DATE: November 3, 2021

SUBJECT: Planning Case #21-025 – No Public Hearing Required
Applicant: Scannell Properties, LLC
Property Location: 4200 Round Lake Road
Request: Site Plan Review

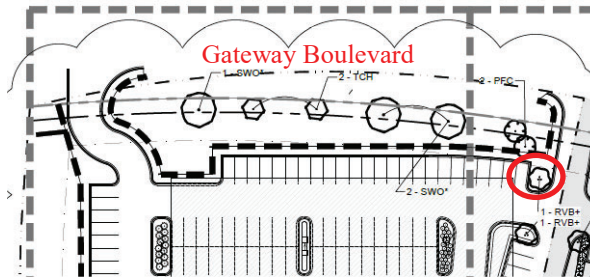
The GB district requires a 50 foot setback for parking areas from public streets and ROW. The Applicant has shown a 49.4 foot setback from the west property line facing 35W and a 28.2 foot setback from the north property line facing Gateway Boulevard ROW. Under the PUD, flexibility was approved for a 20 foot setback from Gateway Boulevard for the main parking area reviewed along with the building design. The proposed parking lot expansion aligns with the placement of the previously approved parking areas along Gateway Boulevard. It was noted during the last review that the proposed parking areas are located approximately 50 feet from the back of curb of Gateway Boulevard. Additionally, that several properties along Round Lake Road and Gateway Boulevard have similar or greater reduction in parking lot setbacks.

If the Planning Commission feedback is generally supportive of site plans as submitted, the Applicant would be required to submit for a Planned Unit Development Amendment in order to seek approval of flexibility for parking setbacks. Site Plan Review authority is limited in approval to plans prepared in accordance with city codes. The Applicant would be required to amend the site plans to adhere to a 50 foot setback for the expanded parking area under the Site Plan Review. Planning Staff has included a recommended condition of approval that an amended site plan that complies with parking setbacks would be required for Zoning Department approval prior to issuance of permits.

- 16) The Applicant shall be required to submit revised site plans prepared in accordance with city code to the Zoning Department for approval prior to issuance of the building and/or land disturbance permits. Site Plan Review does not include approval of setback flexibility as shown.

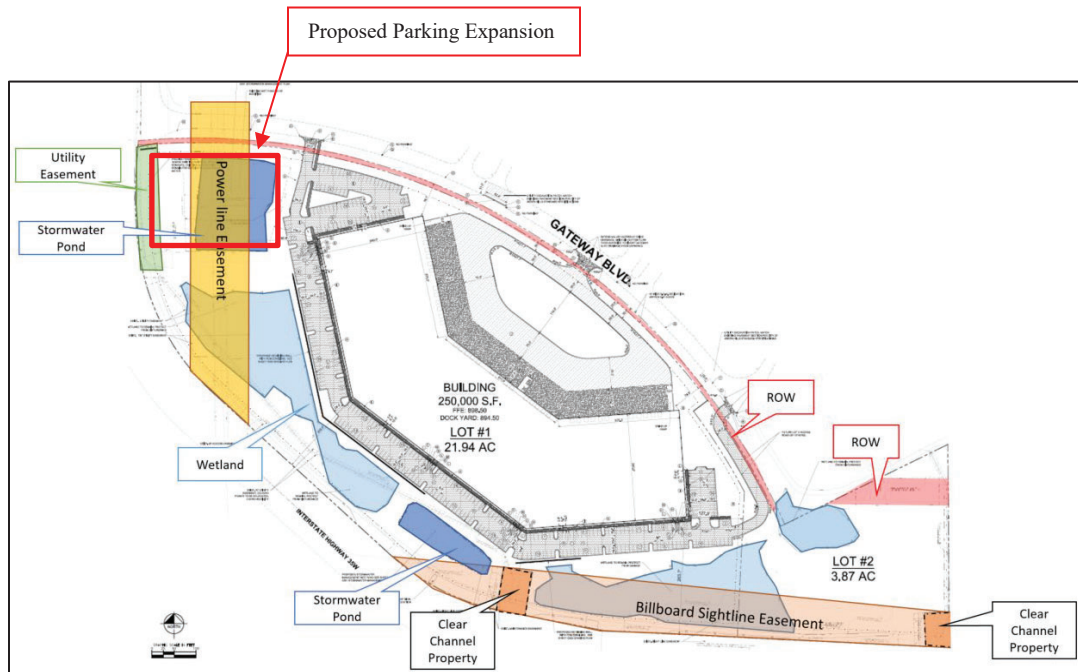
It was noted in the October 2020 Staff Report that when the proof of parking stalls are needed that the Applicant would need to construct an underground retention area in the same area to replace the existing stormwater pond located adjacent to 35W. The Applicant as part of this Site Plan Review is proposing to construct an underground retention system. City code requires that off-street parking areas and drives shall be improved with a paved surface and that such areas shall be so graded and drained so as to dispose of all surface water accumulation within the area as required by the City and the Rice Creek Watershed District. The Public Works Director/City Engineer is reviewing the underground retention system design and infiltration rates with regards to potential impacts of existing wetlands, public versus private runoff, and access to nearby utilities and easements. The parking lot expansion from a zoning review may seem simplistic, but that far be the case from a Public Works/Engineering standpoint. Planning Staff has included the Public Works Director/City Engineer preliminary comments under Additional Review. However given the complexity of this design and parking lot location with the logistics of easements, wetlands, and stormwater maintenance a full review will not be complete for inclusion with this report. Staff will work to have an update on the PW/Engineering review for the Commission at the meeting.

In addition, the Applicant has indicated that the updated site plans and underground retention systems plans have been submitted to the Rice Creek Watershed District, but they have not received a comment review letter or approval from the Watershed. Therefore, Planning Staff recommends Planning Commission consideration of a condition of Site Plan Review would be subject to approval of the Rice Creek Watershed District.

- 5) Prior to the issuance of a land disturbance permit, engineering staff shall approve in writing the final design of parking lot expansion and underground retention system.
